Project	IEEE 802.16 Broadband Wireless Access Working Group < http://ieee802.org/16 >	
Title	Fix for Location Update primitive	
Date Submitted	2006-03-01	
Source(s)	ZTE corporation	xu.ling@zte.com.cn
	Xu Ling

Re:	Contribution on comments to P802.16g-D1
-----	---

Amendment for Location Update message

Figure 498— Location Update Primitives

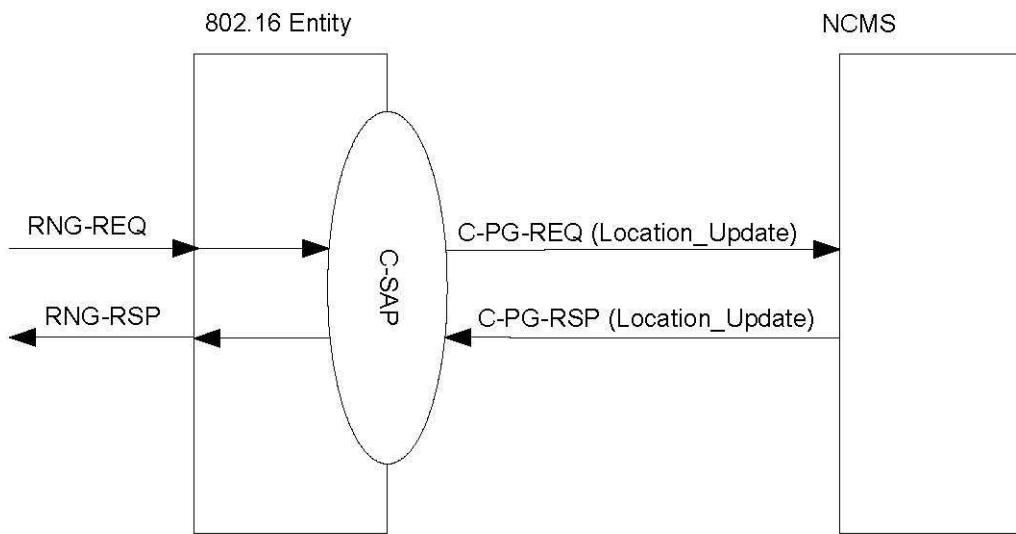
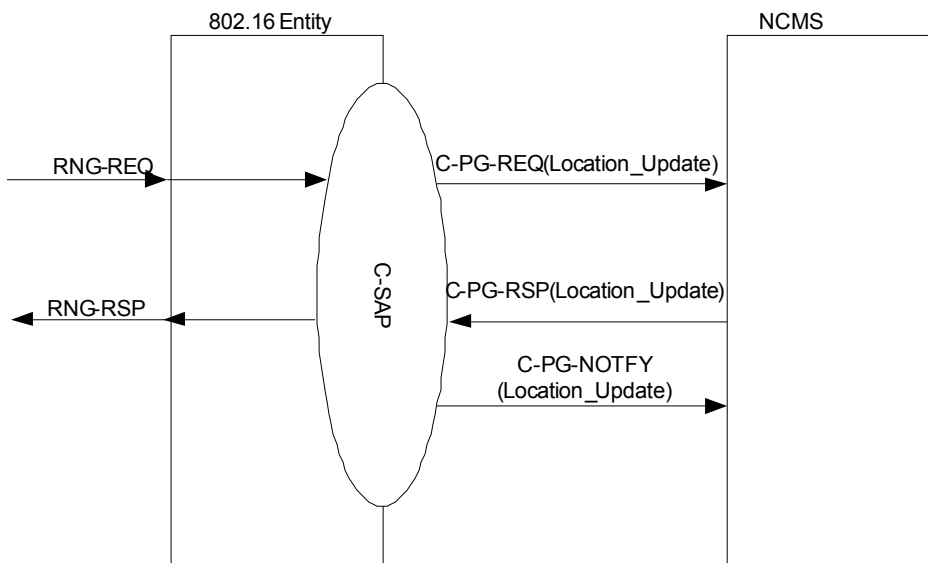
All the above Location Updates are realized by Ranging request/response (RNG-REQ/RSP) message between an MS and a BS, and ~~Location Update request and Location Update response~~C-PG-REQ, C-PG-RSP,C-PG-NOTIFY service primitives are defined between a BS and an NCMS to perform Location Update.

Figure 498 shows service primitives for Location Update between a BS and an NCMS.

[Modify Location Update flow diagram between NCMS and BS as the following]
